ADMINISTRATIVE AMENDMENT (PD) ADD2014-00076

ADMINISTRATIVE AMENDMENT
LEE COUNTY, FLORIDA

WHEREAS, Neal Communities of Southwest Florida, LLC filed an application for an administrative amendment to a Residential Planned Development (RPD) on a project known as Cypress Walk (FKA Cobblestone) for revisions to the approved master concept plan, site development regulations, model home/temporary real estate sales conditions, indigenous wetland, open space, wetland restoration areas, sidewalk condition, and an additional seven deviations from the Land Development Code on property located at 11780 Ben C. Pratt/Six Mile Cypress Parkway, Fort Myers, FL. described more particularly as:

MASTER CONCEPT PLAN

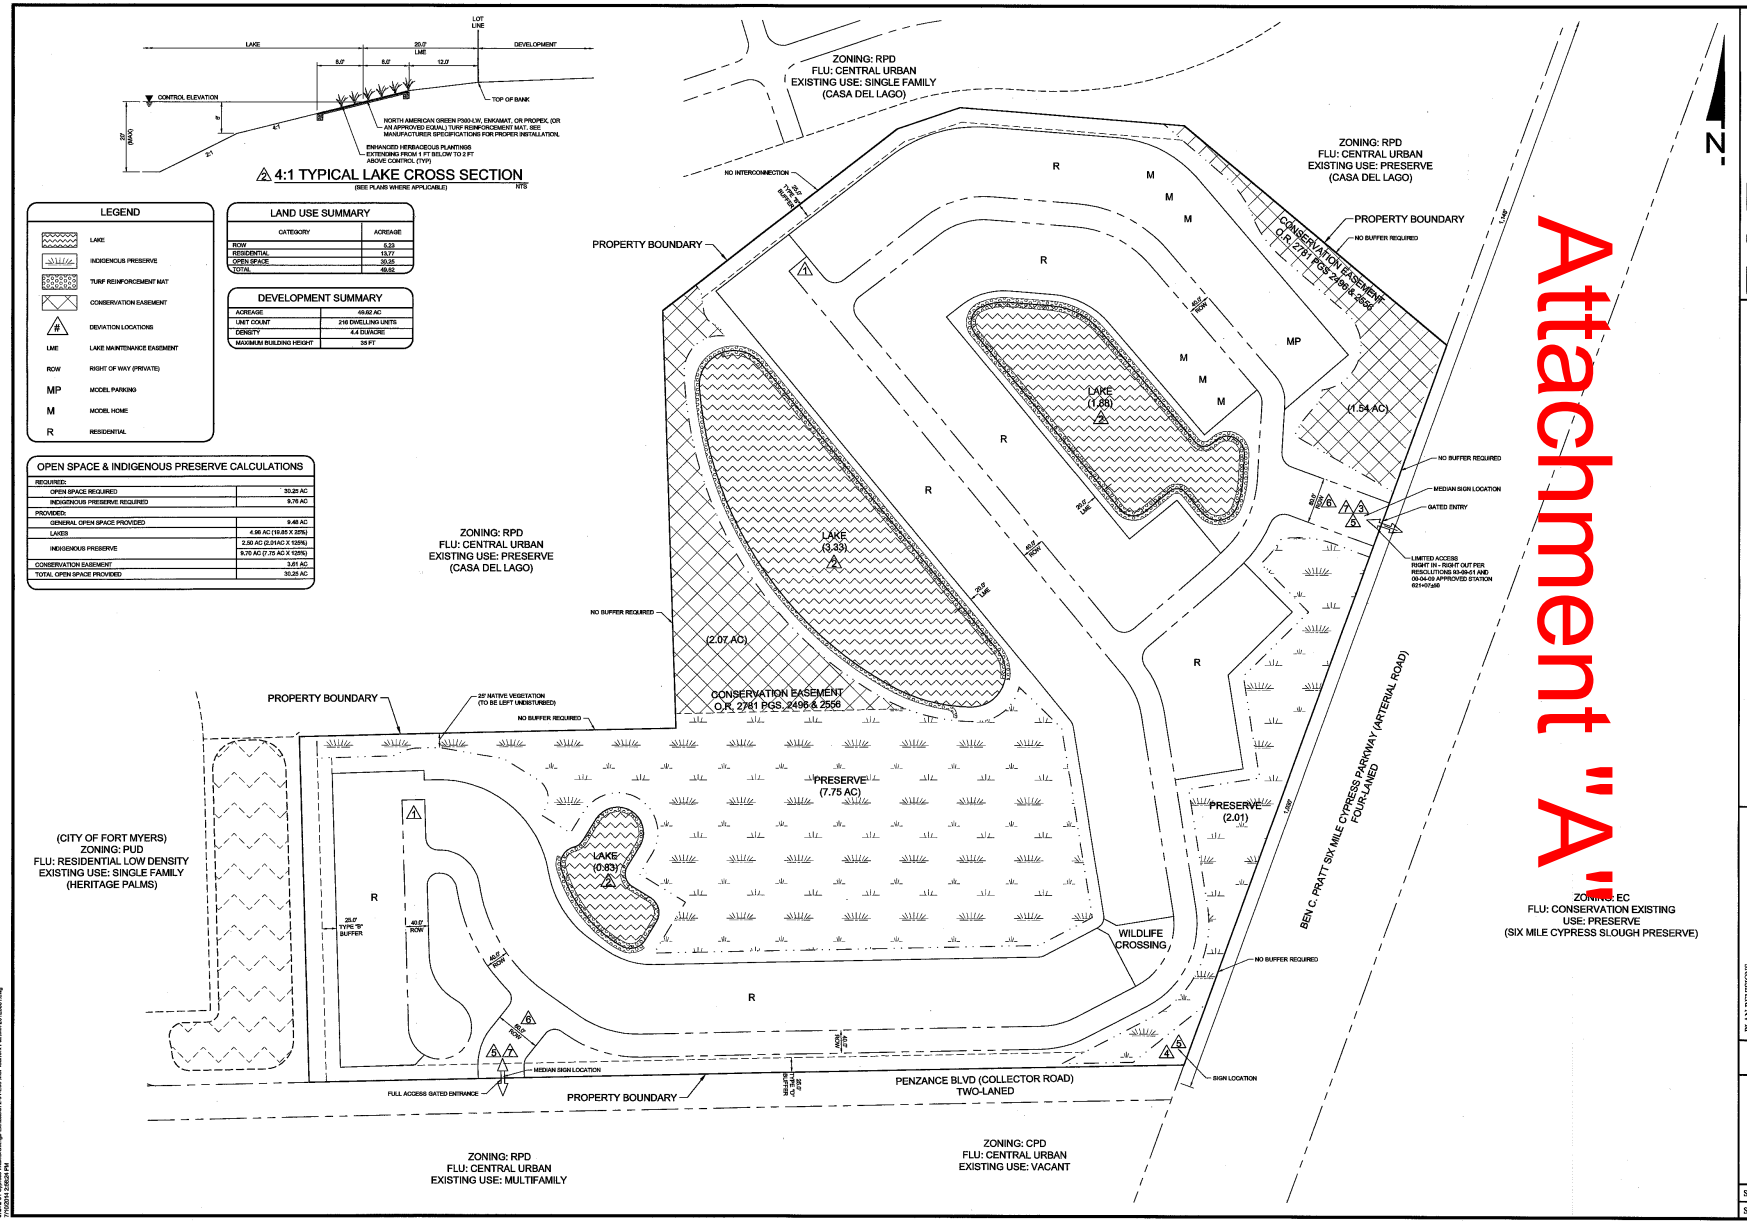
4. The open space table on the MCP must change the indigenous open space to 9.75. Currently, it states 9.97.

5. Did the conservation easement located at the northeastern corner of the property change in size? The recorded conservation easement looks much wider on the recorded documents. Was an amendment submitted to SFWMD to change the size? Please provide documentation.

RESPONSE: Please refer to the revised MCP. The indigenous open space areas have been corrected in the open space table.

RESPONSE: Yes, the configuration shown on the proposed MCP is approved but not recorded (i.e. the release is approved by SFWMD). It is understood that the Administrative Amendment will be conditioned so that recordation is required by time of Certification of Compliance. The companion Development Order Amendment resubmittal will include documentation of the SFWMD approval.

TYPICAL LAKE SECTION N.T.S

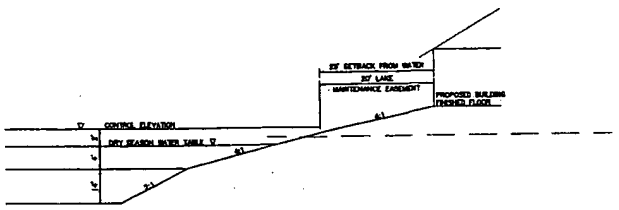
1. Must provide 6:1 lake bank slopes.

The lakes being proposed are deep lakes (12 feet or greater), illustrate a 4:1 slope, deep lake trees, and one littoral plant per one linear foot of the lake shoreline. These illustrations were in compliance with the LDC 10-329 (d) (4) and 10-418(2) at the time of the 2006 development order submittal. In June of 2014, the applicant submitted an amendment to revise the location of one of the lakes and change the site configuration. The current ADD application is required because the site plan has changed and the property regulations are being revised in the DCI2005-00001. The applicant must request new deviations from the LDC if the site plan cannot meet the LDC requirements. Therefore, the applicant has requested a deviation from LDC 10-329 (d) (4) to allow a 4:1 lake bank slope with enhanced herbaceous plantings and turf reinforcement mats instead of the code required 6:1 lake bank slope. The applicant provided calculations for the enhanced herbaceous plantings via e-mail on July 17, 2014. ES staff refers to Development Services for compliance with lake bank slope comments per LDC 10-329(d) (4). If Development Services staff recommends approval to allow 4:1 lank bank slopes instead of 6:1, then ES staff offers the following condition:

RESPONSE: Please refer to the revised Deviations & Justifications narrative enclosed. Additional justification has been provided in regards to the existing site constraints memorialized through various state, local and federal permits, and a detailed description of the erosion control measures through enhanced plantings, TRM and location of gutters/down spouts has been provided.

As part of a local development order approval for the 4:1 lake bank slope, an additional 4600 herbaceous plants in two inch liners must be provided to supplement the turf reinforcement mat per the following specifications:
